Byron Station, Unit 1 and Unit 2
Facility Operating License Nos. NPF-37 and NPF-66
NRC Docket Nos. STN 50-454 and STN 50-455

Subject: Revision to the Reactor Coolant System Pressure and Temperature Limits
Report, Byron Station Unit 1 and Unit 2

**Byron Station Unit1 Reactor Coolant System Pressure and Temperature Limits Report
Revision 1**

**Byron Station Unit 2 Reactor Coolant System Pressure and Temperature Limits Report
Revision 1**

Figure 2.1:

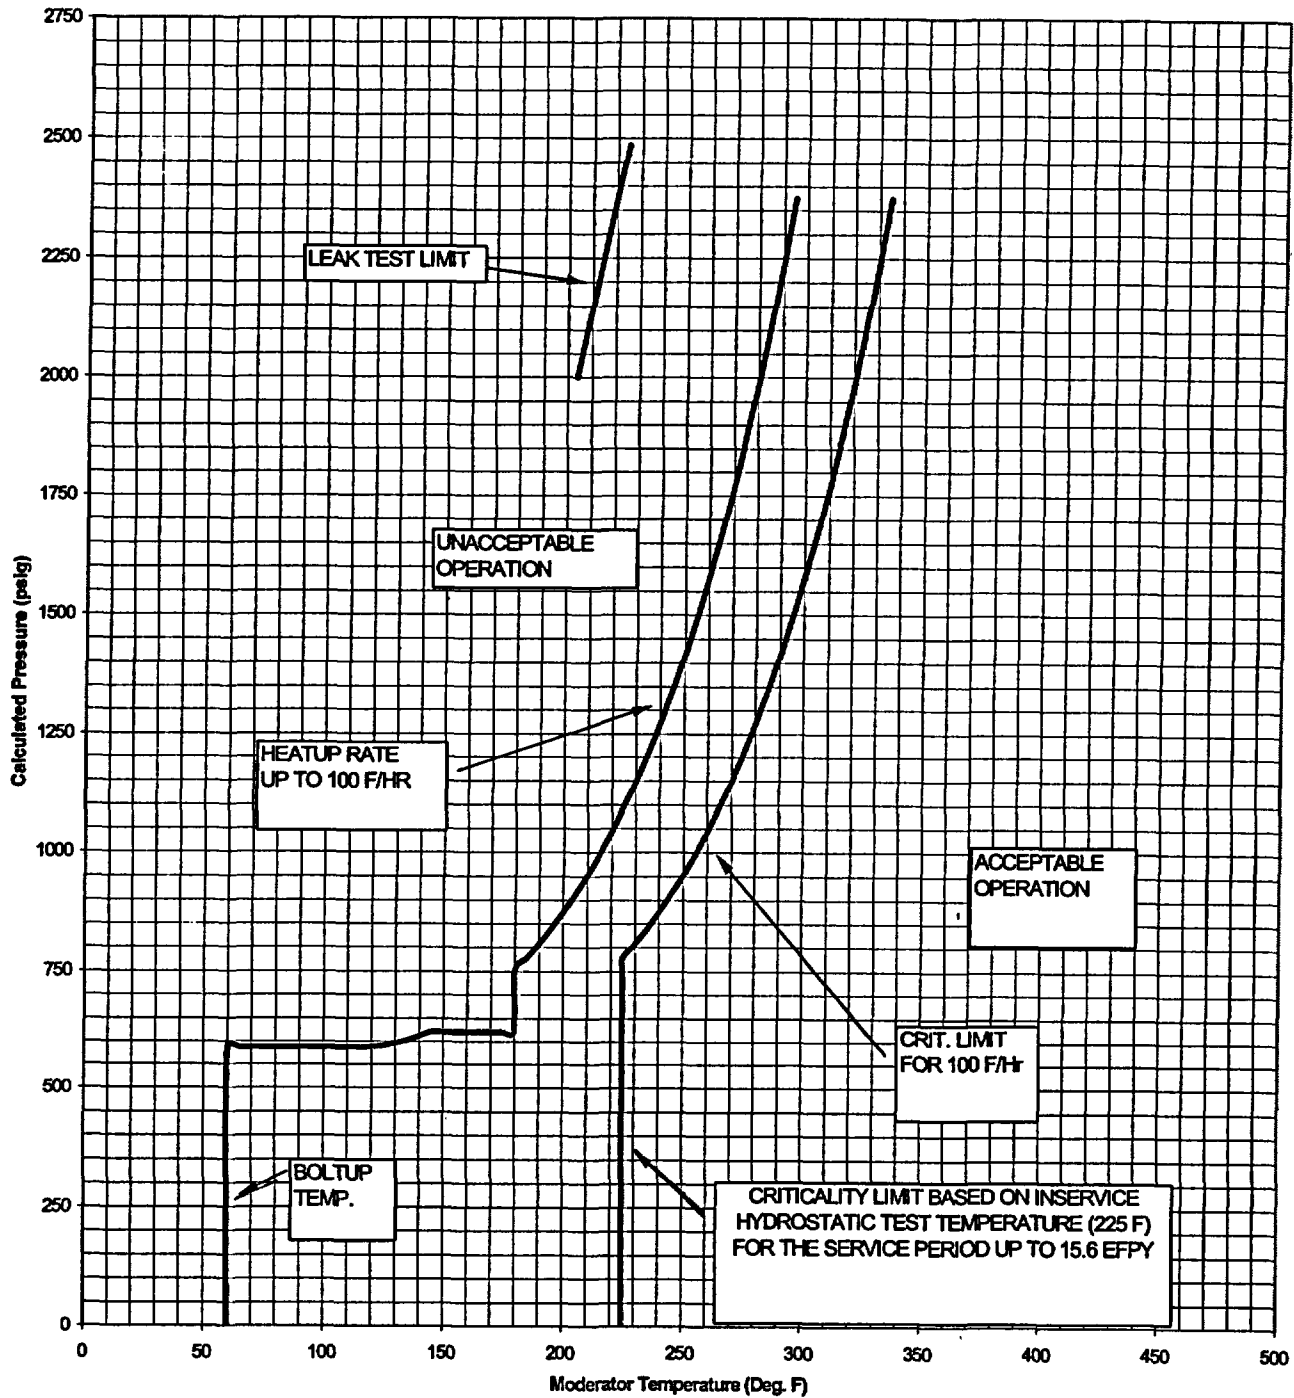
- The applicability for Figures 2.1, 2.2, and 2.3, and Tables 2.1 and 2.2 was revised from 16 to 15.6 EFPY. The applicable period is being revised due to power uprate impacts and the increased neutron flux.

Byron Unit 1 Reactor Coolant System Heatup Limitations (Heatup rates up to 100°F/hr) Applicable for the First 15.6 EFPY (Without margins for instrumentation errors and using 1996 Appendix G Methodology)

Figure 2.1:

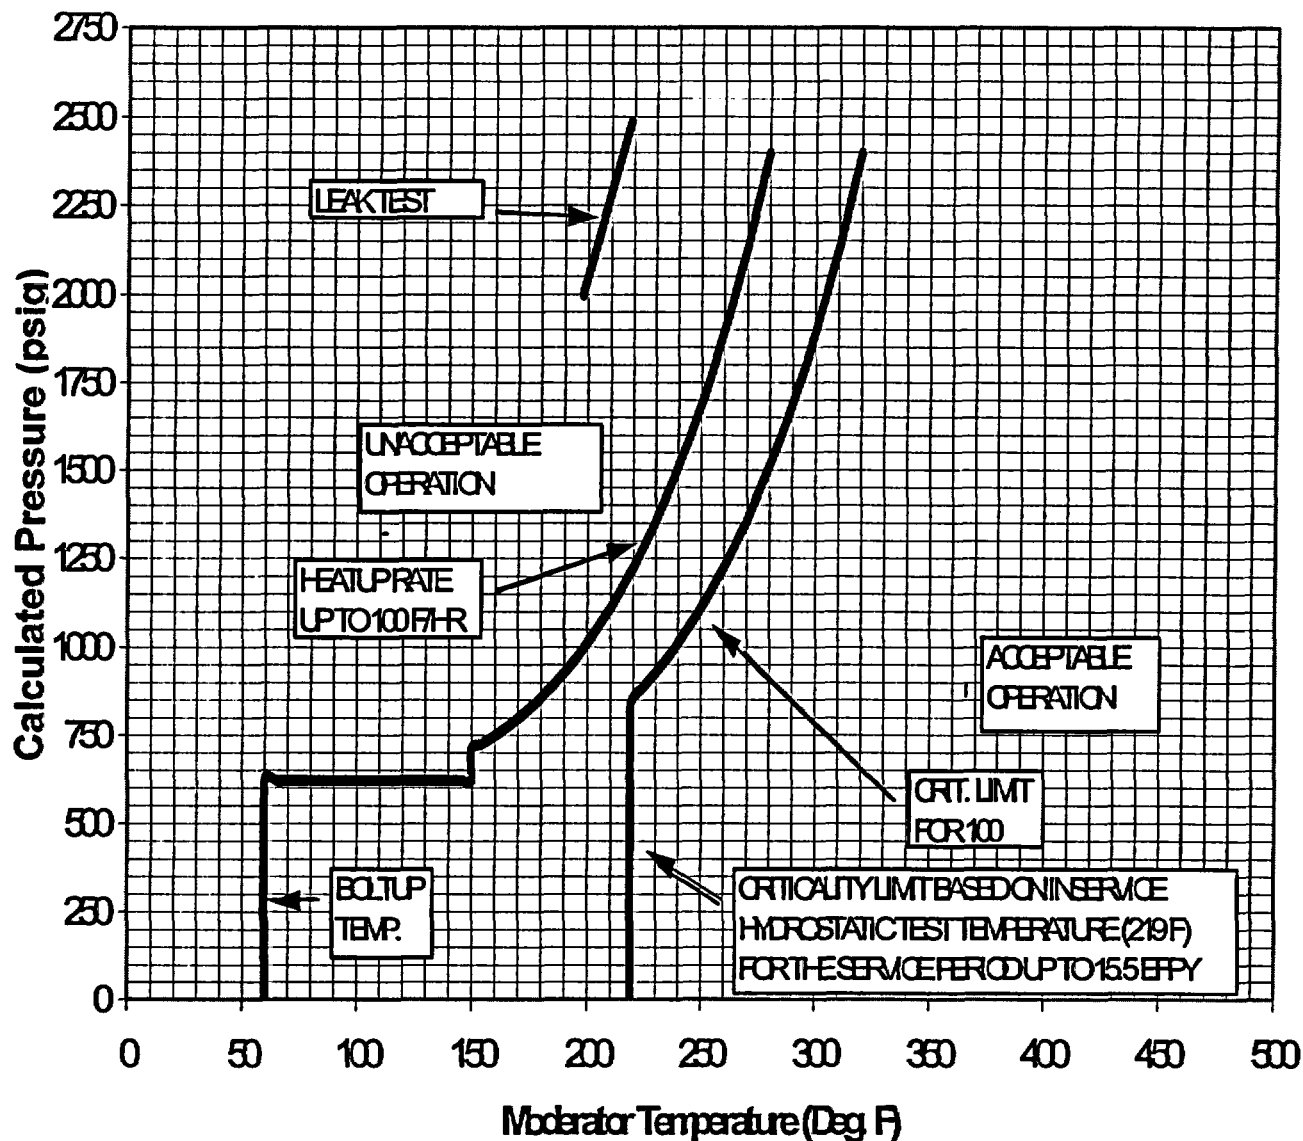
- Administrative/editorial changes were made to paragraph 1.0
- Reference 20 was added to paragraph 2.0
- The applicability for Figures 2.1, 2.2, and 2.3, and Tables 2.1 and 2.2 was revised from 16 to 15.5 EFPY. The applicable period is being revised due to power uprate impacts and the increased neutron flux.

Byron Unit 2 Reactor Coolant System Heatup Limitations (Heatup rates up to 100 °F/hr) Applicable for 15.5 EFPY (Without margins for instrumentation errors and using 1996 Appendix G Methodology)
